U S NAVY RESPONSES TO NORTH CAROLINA DEPARTMENT OF ENVIRONMENT AND  
NATURAL RESOURCES AND U S EPA REGION IV COMMENTS ON THE DRAFT  
TECHNICAL MEMORANDUM SUPPLEMENTAL GROUNDWATER INVESTIGATION FOR  
OPERABLE UNIT 1 (OU 1) SITE 78 MCB CAMP LEJEUNE NC

**Response to Comments**  
**Draft Supplemental Groundwater Investigation Technical Memorandum**  
**Operable Unit 1, Site 78**  
**Marine Corps Installations East – Marine Corps Base Camp Lejeune**  
**(MCIEAST-MCB CAMLEJ), North Carolina**

DATE: March 12, 2014

Figure X  
 Total CVOC Plume Map - North  
 Surficial Aquifer  
 Site 78 Technical Memorandum  
 MCIEAST - MCB CAMLEJ  
 North Carolina

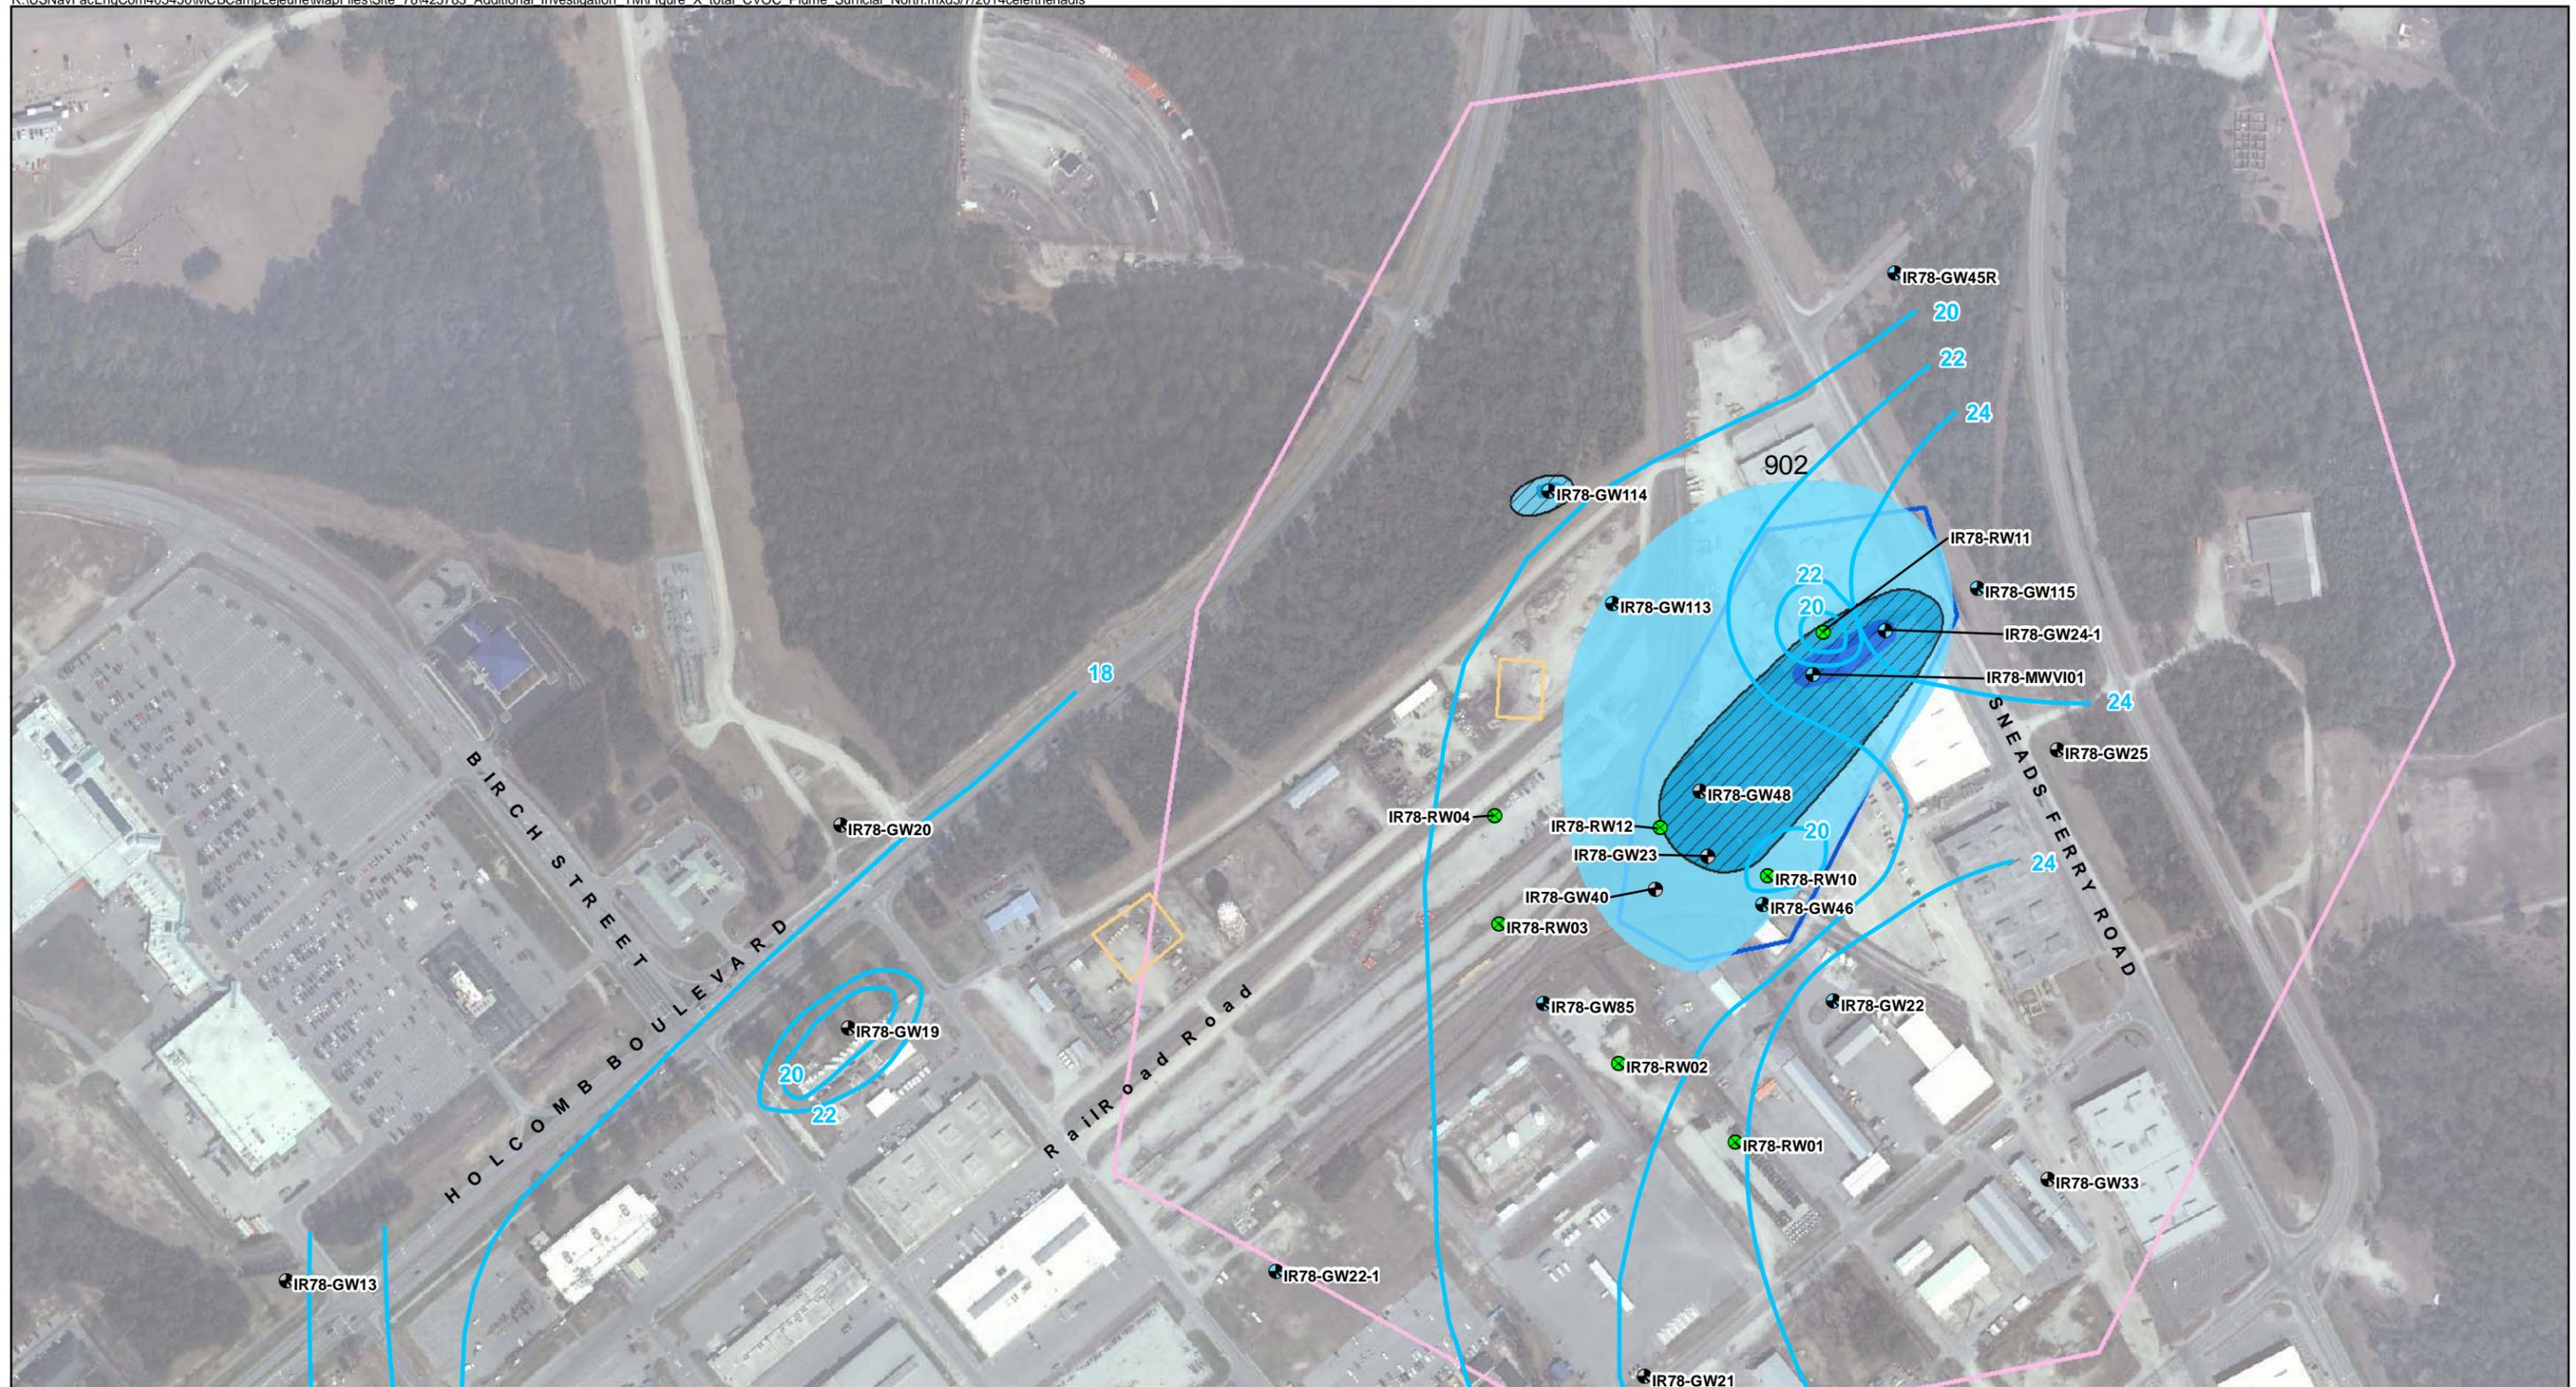
1. Recommended more clearly presenting the exceedances vs. detections on the groundwater plume maps.

**All of the plume figures in the Supplemental Groundwater Investigation Technical Memorandum will be updated to more clearly identify the areas of NCGWQS/MCL exceedances (see attached example). A note will be added to the legend of the final figure that says “Detections of BTEX/CVOCs below NCGWQS are shown to further refine the conceptual site model.”**
